***Regular Meeting of the
Building Inspection Commission
November 14, 2025***

Information Sheet S-05

Slope Protection Act

Slope Protection:

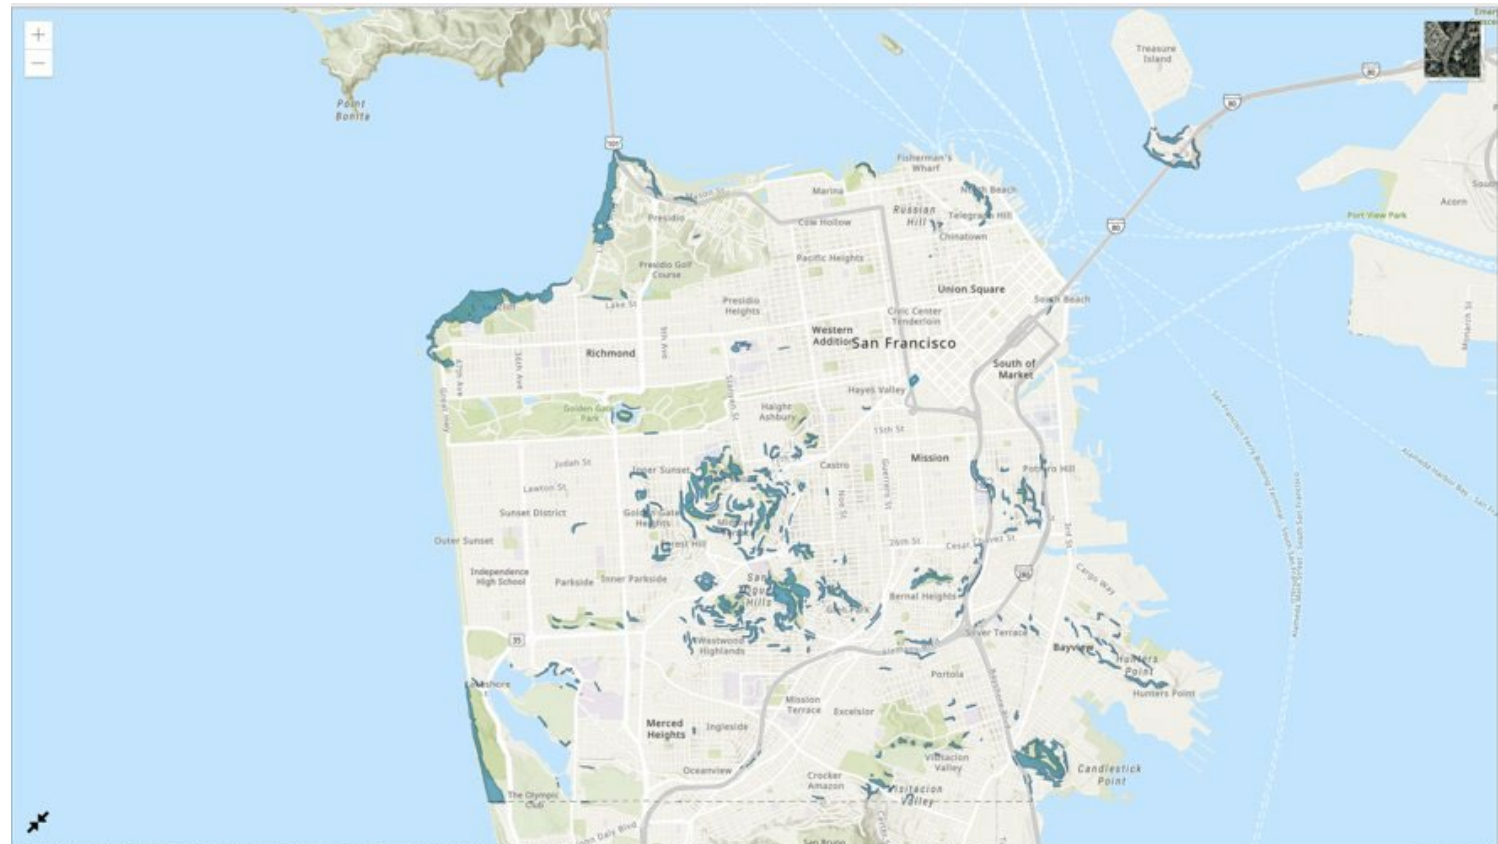
Under the previous Slope Protection Act, the shaded areas were subjected to heightened scrutiny if any part of the property featured a 25% slope.

Now, the heightened review is for designated landslide zones and the Mount Sutro and Edgehill areas of the City.
